ADVISORY
 BULLETIN

No. 2001-06

Official Notification Federal Boat Safety Act Flywheel Nut Retorque - 115 EFI Four Stroke

2001 115 EFI Four Stroke

Torque Flywheel Nut to 140 lb-ft (189.8 N m)

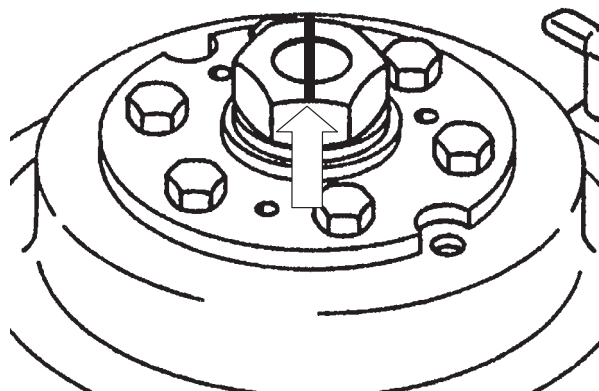
1. Remove the flywheel cover and loosen the flywheel nut.

IMPORTANT: Do Not use an impact gun to torque the nut.

2. Retorque the flywheel nut to 140 lb-ft. (189.8 N·m) with a torque wrench.

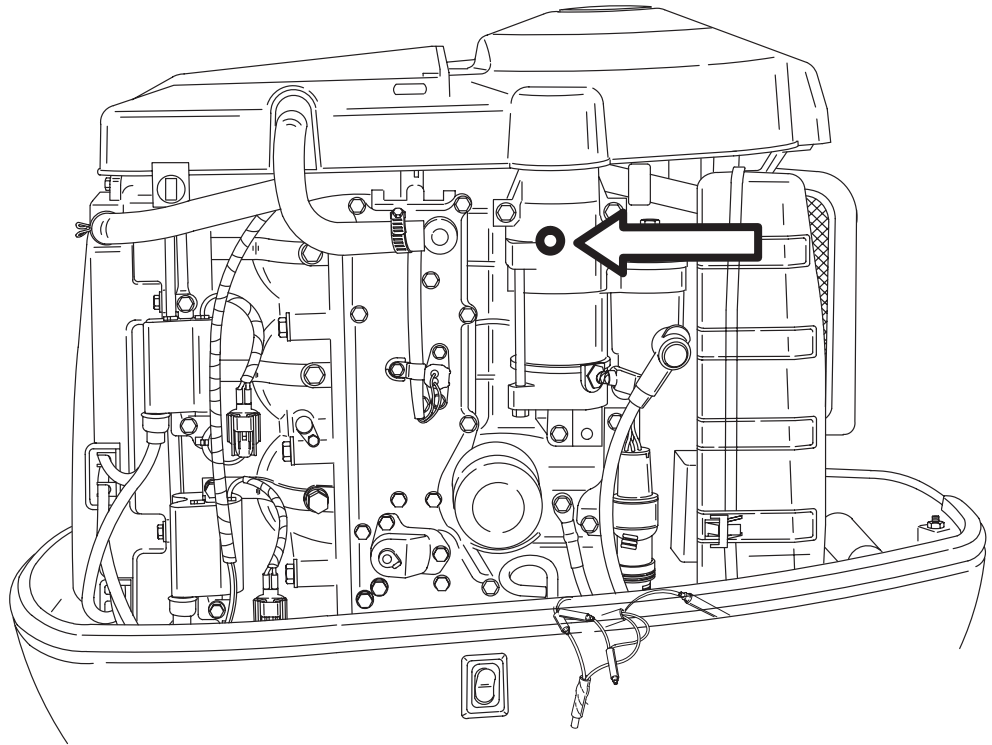
3. Mark a black line on the end of the crankshaft and both flywheel nut surfaces.

4. Mark a black dot on the starter motor housing.
